# Access Compliance Report

## Public Rights-of-Way

### (Curb Ramps)

Intersection ID: 10393	Main Street: LIMA_AV	Cross Street: ROZZELLES_FERRY_RD	Location: NE
ADA ID: 5824948DDD30	Ramp Type: PerpDiag	Initial Pass/Fail: Fail	Overall Compliance: No
Codes/Mitigation Info/Possible Solution		Field Measurements/Component Compliance	
Severity Score: 48.75

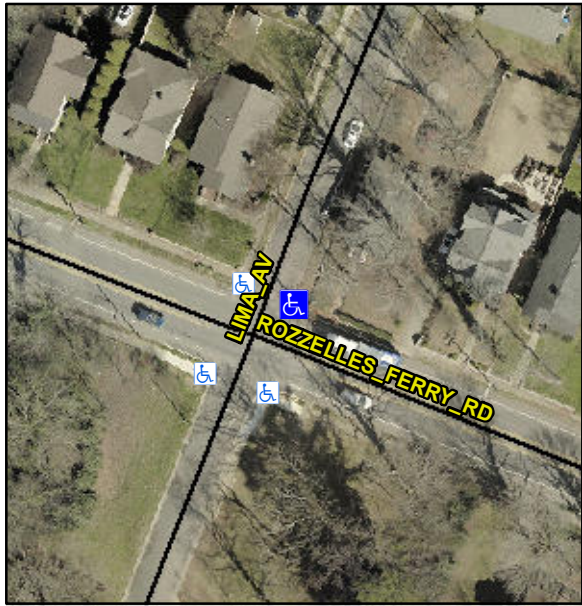
Not Found, R304.5.1, R304.2.2, R304.5.3

Compliance	Description	Data	Compliance	Description	Data
N/A	Ramp Length (in)	67.0	No	Ramp Slope (%)	9.1
No	Ramp Width (in)	31.0	No	Ramp XSlope (%)	3.2
N/A	Flare Type LT	N/A	N/A	Flare Type RT	N/A
N/A	Flare Slope LT (%)	N/A	N/A	Flare Slope RT (%)	N/A
N/A	Flare Traversable LT?	N/A	N/A	Flare Traversable RT?	N/A
N/A	Landing Length (in)	N/A	N/A	DWS Provided?	N/A
N/A	Landing Width (in)	N/A	N/A	DWS Contrast?	N/A
N/A	Landing Slope (%)	N/A	N/A	DWS Length (in)	N/A
N/A	Landing X Slope (%)	N/A	N/A	DWS Full Width?	N/A
N/A	Landing Curb? (Y/N)	N/A	N/A	DWS Offset (in)	N/A
N/A	Shared Landing?	N/A			
N/A	Gutter Ponding?	Yes	N/A	Gutter Slope (%)	N/A
N/A	Gutter Lip Ht (in)	N/A	N/A	Gutter X Slope (%)	N/A
N/A	Painted X Walk1?	No	N/A	Painted X Walk2?	No
	X Walk 1 Direction	To NW		X Walk 2 Direction	To SW
N/A	X Walk 1 Width (in)	N/A	N/A	X Walk 2 Width (in)	N/A
	X Walk 1 Slope (%)	2.6		X Walk 2 Slope (%)	3.4
	X Walk 1 X Slope (%)	2.9		X Walk 2 X Slope (%)	1.8

Remove & Replace Curb Ramp With Two New Directional Ramps or Equivalent.
